ADDENDUM NO. 03

**Baggage Screening Improvements – Phase 2A**  
**[Loading Dock Reconfiguration, Sheriff’s Checkpoint Removal, Jetway Installation**  
**(Gate 30, 46, 47), IAB Airside Trash Remodel, North Checkpoint Relocation]**

PROJECT NO. A044-09002

DATE OF ADDENDUM: June 14, 2011

**GATE D30 JET BRIDGE ELECTRICAL POWER ONE LINE DIAGRAM**  
 NOT TO SCALE

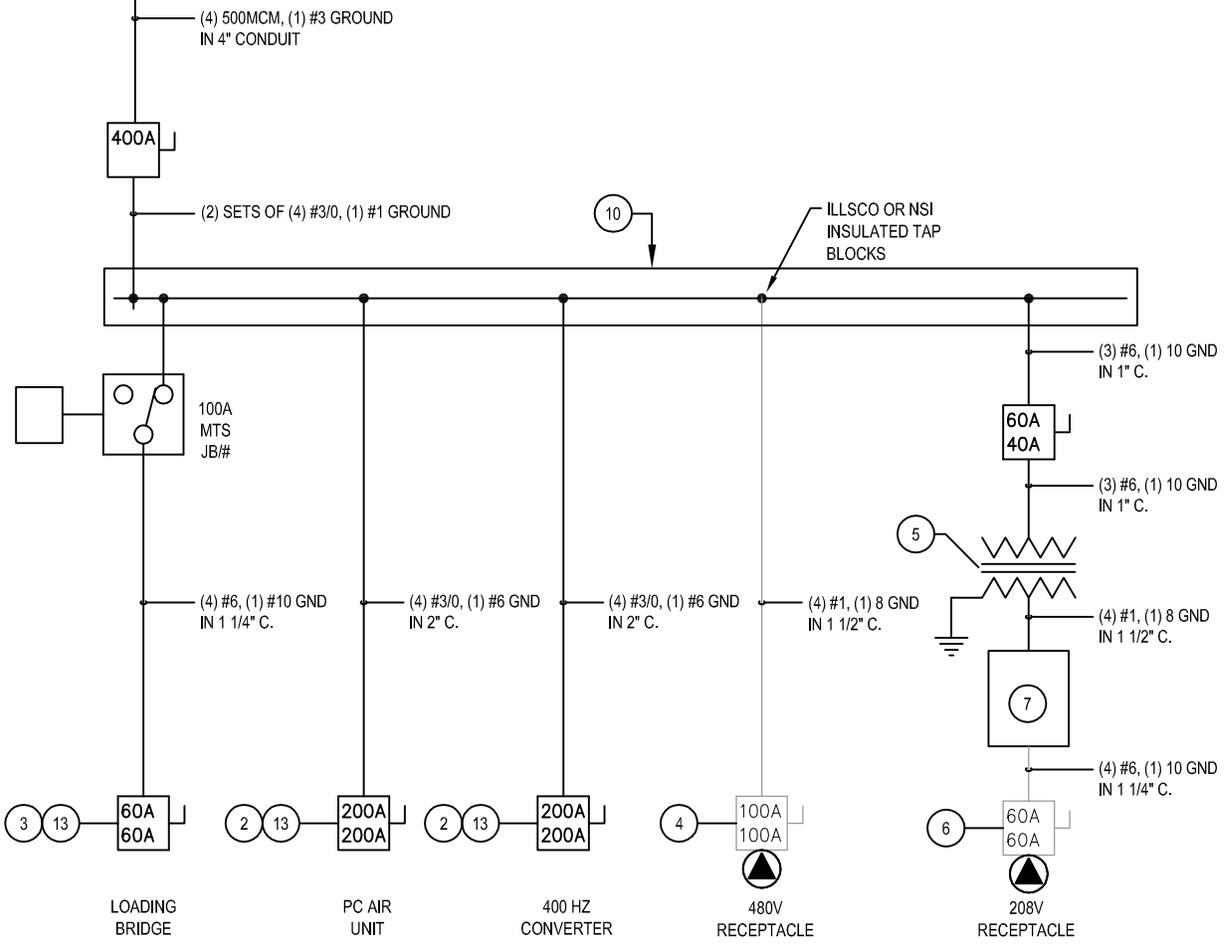
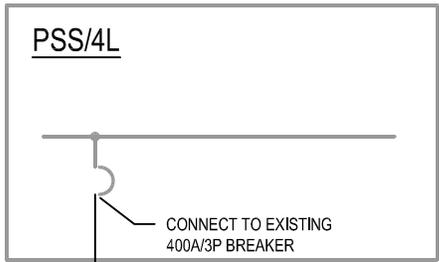
**E701A:** Revised the one line diagram **2/E701A** to show the new feeder for Gate D46 and 47 (refer to attached drawing).  
Adding a new one line diagram in detail **5/E701A** for the feeder to gate D30 (refer to attached drawing).
